To T.E. Johnson
Subject Problem Alert
Large Settlements Due to
Incorrectly Placed Backfill
Copies to K. Wiedner
J. Milandin

To E. A. Rumbaugh
Subject Problem Alert - Large Settlements
Due to Incorrectly Placed Backfill
Copies to T. E. Johnson W. T. Kellermann
G. A. Tuveson S. L. Blue
S. I. Heisler

Subject: Large Settlements Due to Incorrectly Placed Backfill

MIDLAND SOILS
CHRONOLOGY AND SUMMARY

APPLICANT: Consumers Power Company
FACILITY: Midland Plant, Units 1 and 2
SUBJECT: SUMMARY OF JANUARY 26, 1982 TELEPHONE DISCUSSION REGARDING
SURCHARGE RESULTS FOR THE BWST FOUNDATIONS

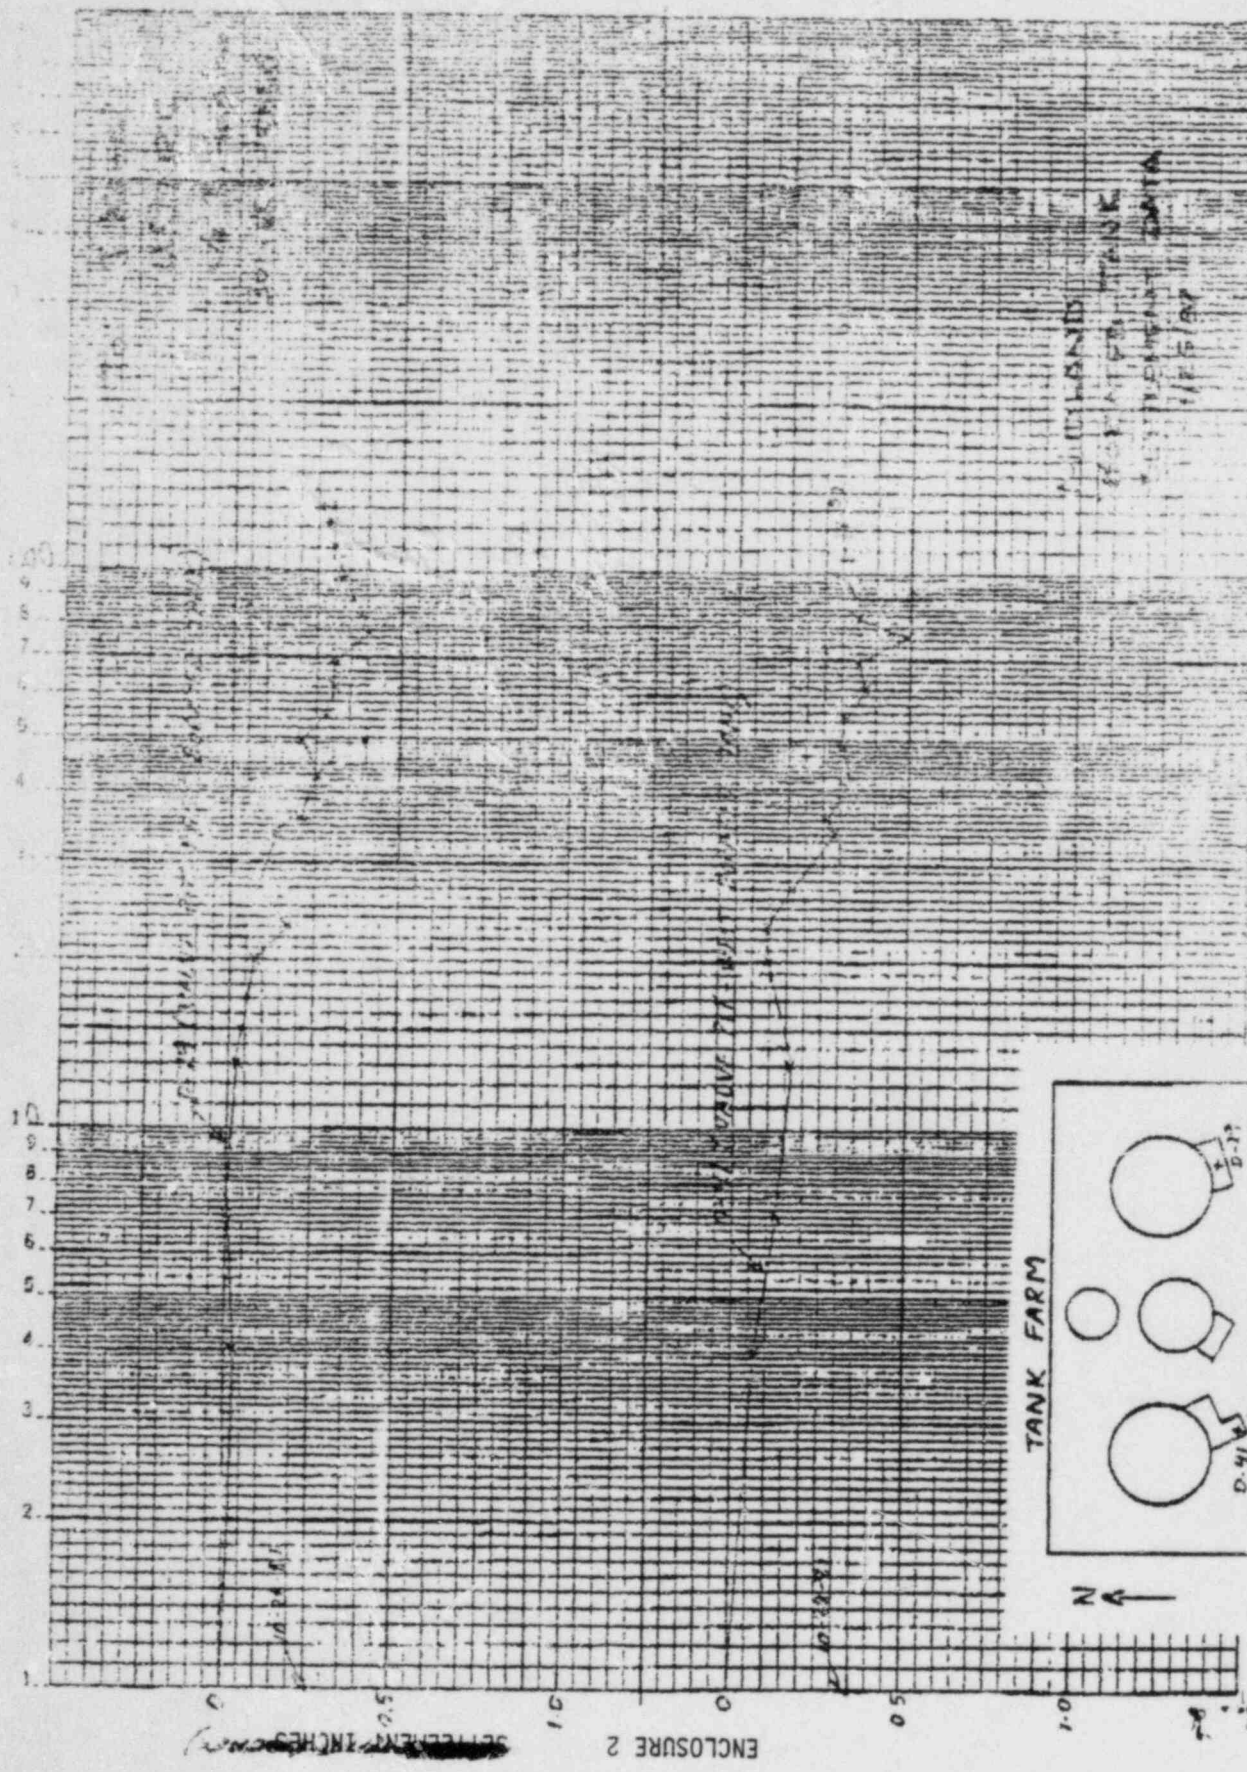
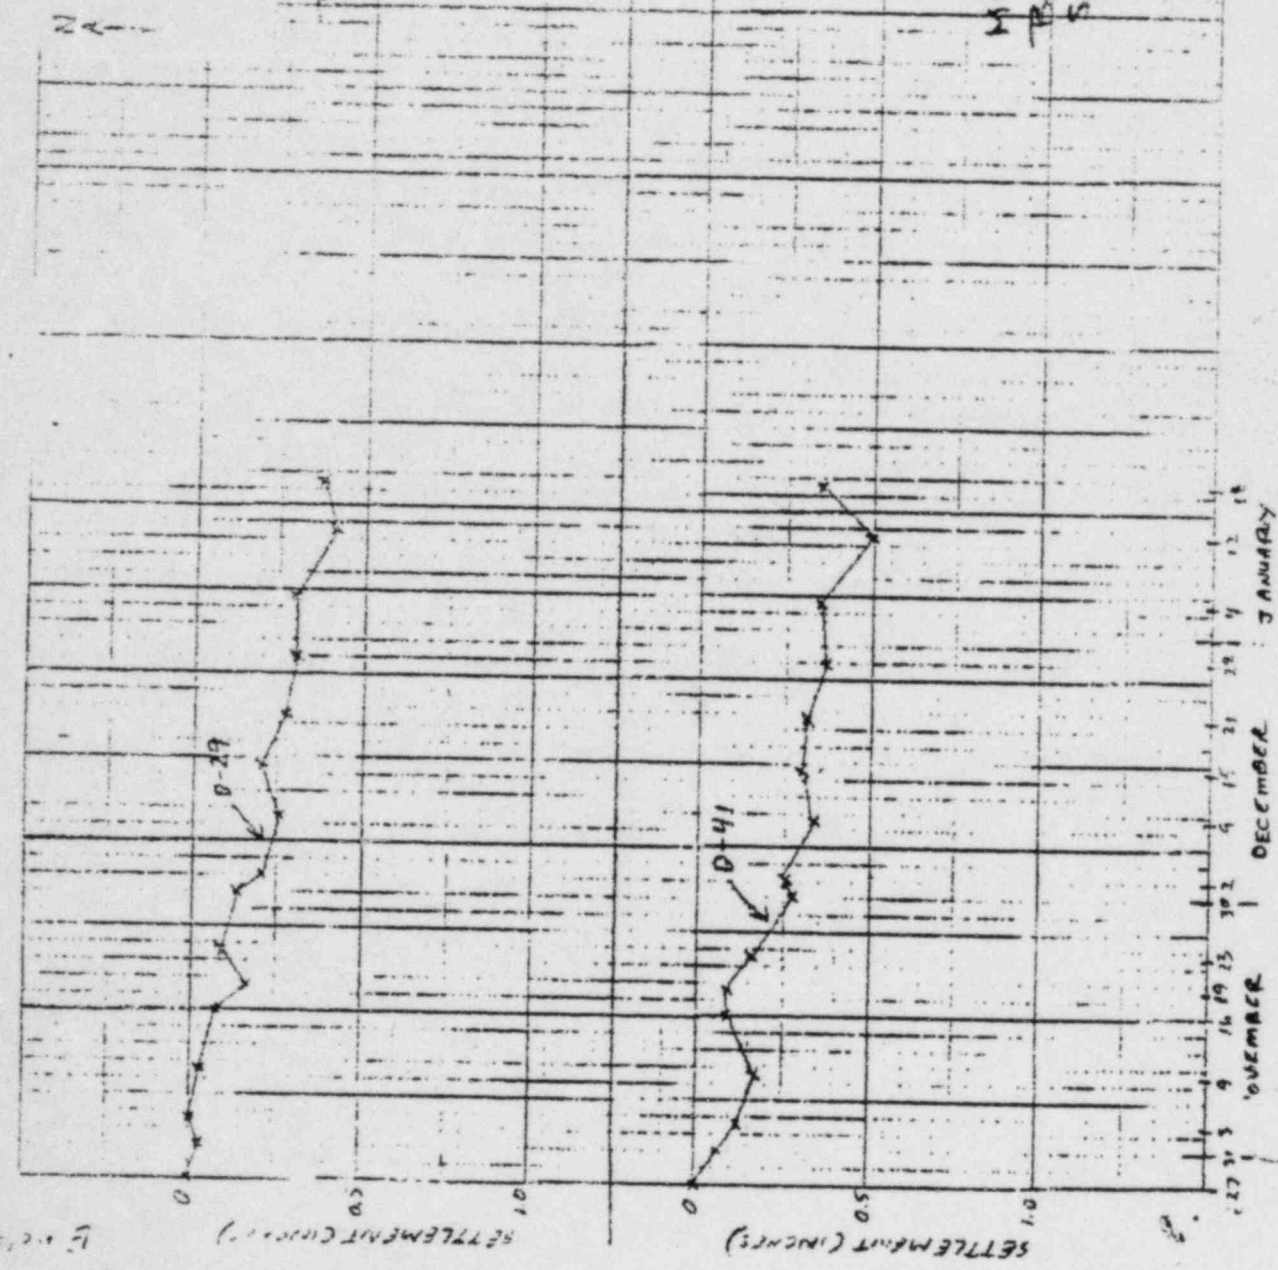
Mr. Kane replied that the settlement data for markers U-29 and U-41 do not clearly indicate that the foundation soils beneath the valve pit are in secondary consolidation. If the questionable readings of January 12, 1982 are excluded, and average smooth settlement curve through the plotted points could be drawn since November 24, 1981 (the date for placing the third and final surcharge load increment) which would indicate the foundation soils are still in primary consolidation. Mr. Kane requested that the settlement data for the other markers be provided for review.

1. The criteria for maximum settlement is 0.5". Although the curve for marker U-41 on January 12, 1982 reads 0.5", Consumers does not consider this to be an accurate reading, as demonstrated by the January 18, 1982 reading which shows about 0.4".
2. Other measured points also show the dip which occurred on January 12, 1982. Consumers speculates that survey inaccuracies may be at fault for the January 12, 1982 readings.
3. Consumers feels the current data demonstrate that the fill beneath the BWST foundations is now in secondary consolidation. The secondary consolidation rate for the tanks has been estimated to be 1/2" per decade.
